RE: Addendum to Environmental Impact Report for Mammoth Yosemite Airport
Terminal Area Development Project Improvements (SCH #2019100384)

**REVISED AIRPORT RESCUE AND
FIRE FIGHTING STORAGE
FACILITY LAYOUT**
April 2022
Revisions shown in **RED**

EXHIBIT A

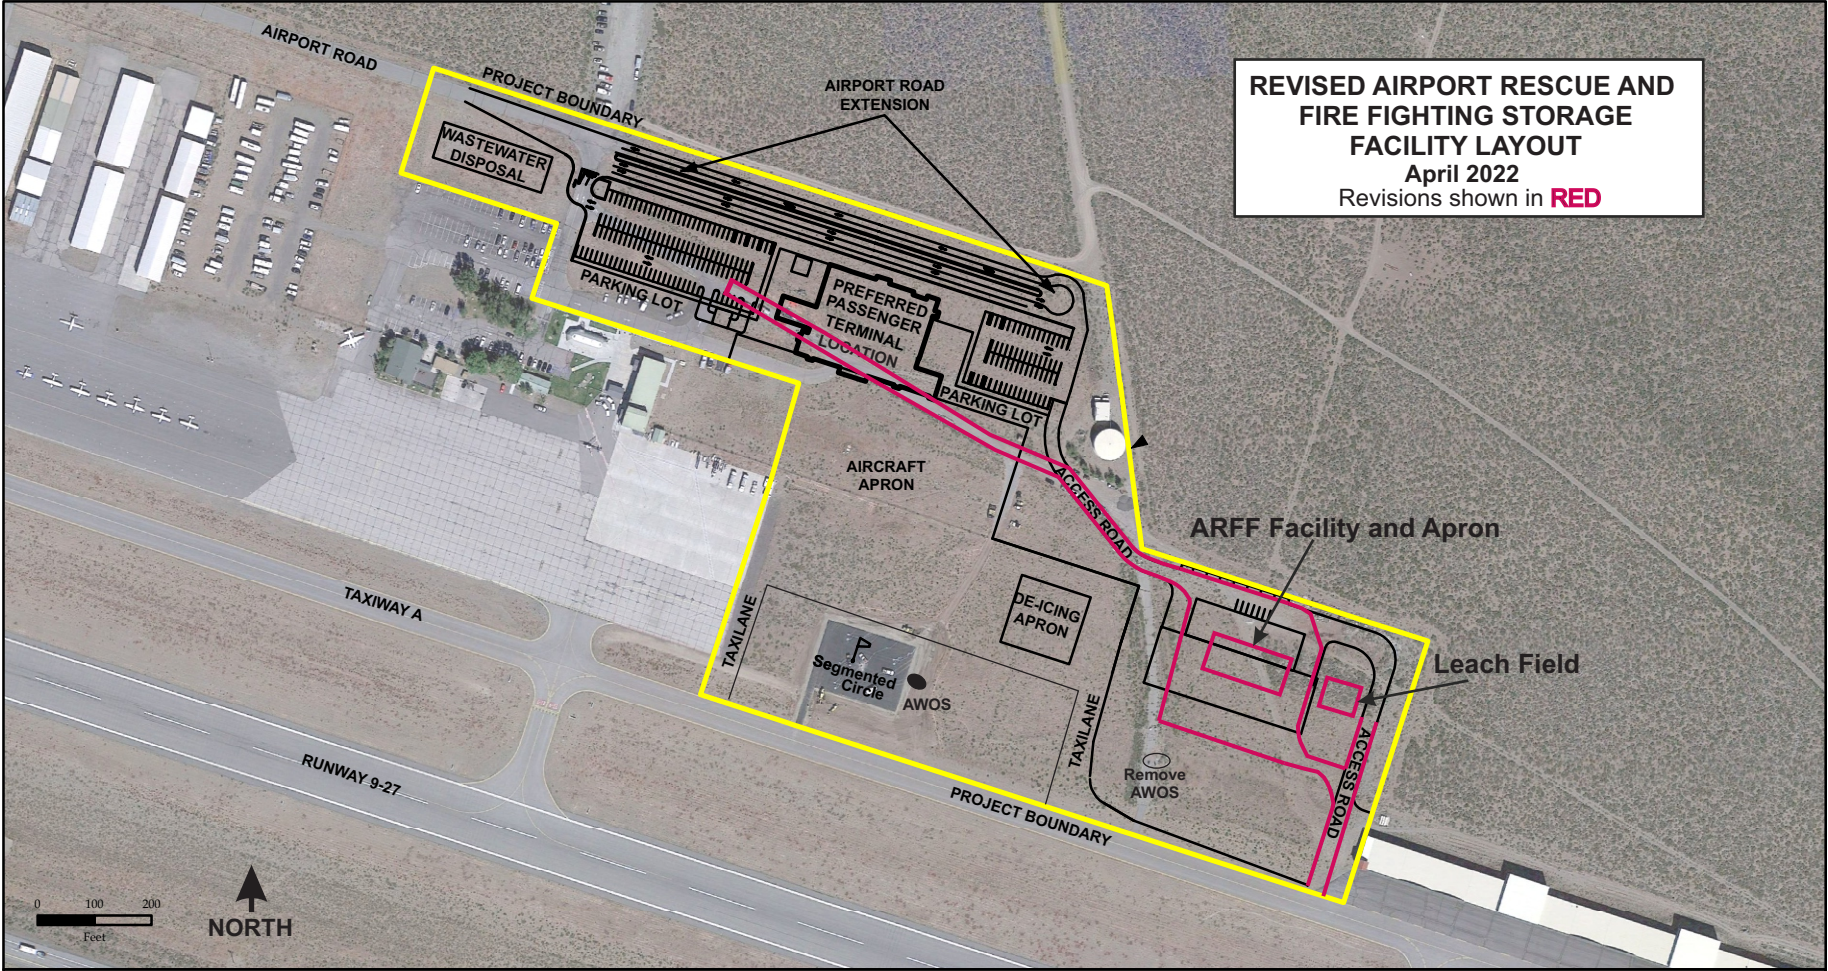
This memo constitutes an addendum to the Environmental Impact Report for the Mammoth Yosemite Airport Terminal Area Development Project (TADP) Improvements. The Town Council certified the EIR on October 6, 2021. Since certification of the EIR, the Town determined that the Aircraft Rescue and Fire Fighting (ARFF) facility requires minor design changes. Those changes are intended to improve facility efficiency and provide additional space for airport operations. The proposed location of the ARFF facility does not change. Proposed changes to the EIR's description of the ARFF are shown in Table 1 below and in the attached Exhibit A:

| TADP Approved | TADP Proposed Revision |
|--|---|
| ARFF Building: footprint 8,400 sq. ft. | ARFF Building: footprint 10,350 sq. ft. |
| Apron and parking: approximately 3,300 sq.yds. | Apron and parking: approximately 3,900 sq. yds. |
| Access Road: approximately 800 feet | Access Roads: 1,700 feet |
| Leach Field: Not specific to ARFF | Leach Field: For ARFF only |

The modified ARFF facility, apron and parking area, and access road are located within the original approved project area. The access road has been lengthened, but this involves repaving an existing road to serve the ARFF facility. A sanitary leach field was originally proposed near the passenger terminal building; it is now proposed adjacent to the ARFF facility. Based upon a groundwater study, the proposed leach field would be downgradient of two water wells which serve the airport.
